CS Memorandum No. 1444

Subject: Configuration Management Board Meeting No. 125

CMB Meeting Minutes #125

SUBJECT: Configuration Management Board Meeting # 125 – Rev. No. 0

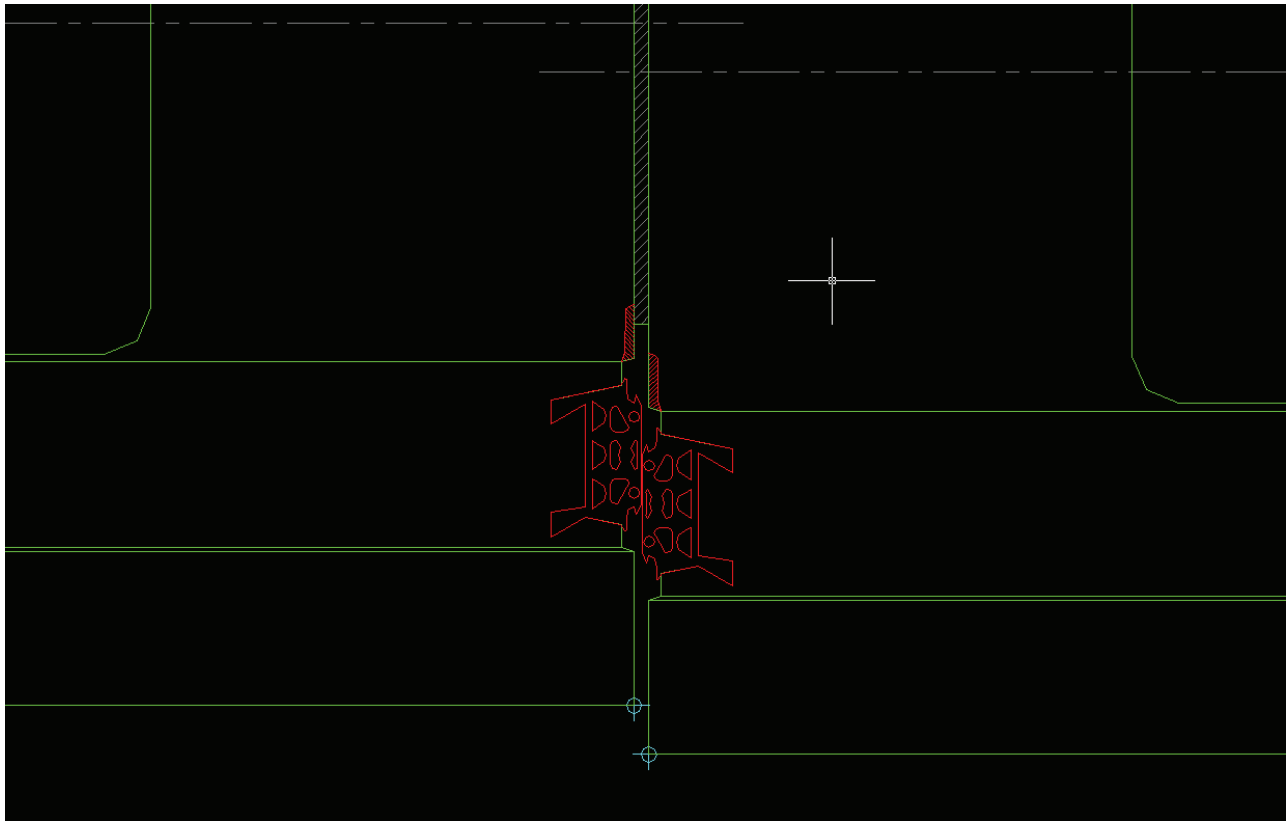
- Segment Bearing:
 - Along the circumferential faces the spalling results in a minor reduction of bearing area used to resist the forward thrust of the TBMs, along the radial faces this spalling will affect the ability of the segments to resist birdsmoothing and bursting. Based on a review of our calculations for the segmental liner, substantially more area would have to be removed from the segments in order for this to be of concern. To provide clarity in repair requirements, the following guidelines are provided for the need to repair spalling in terms of bearing performance:
 - Repairs are not required if:
 - The spall is no deeper than 0.1 inches (2.6mm), that is, the depth of the stress relief;
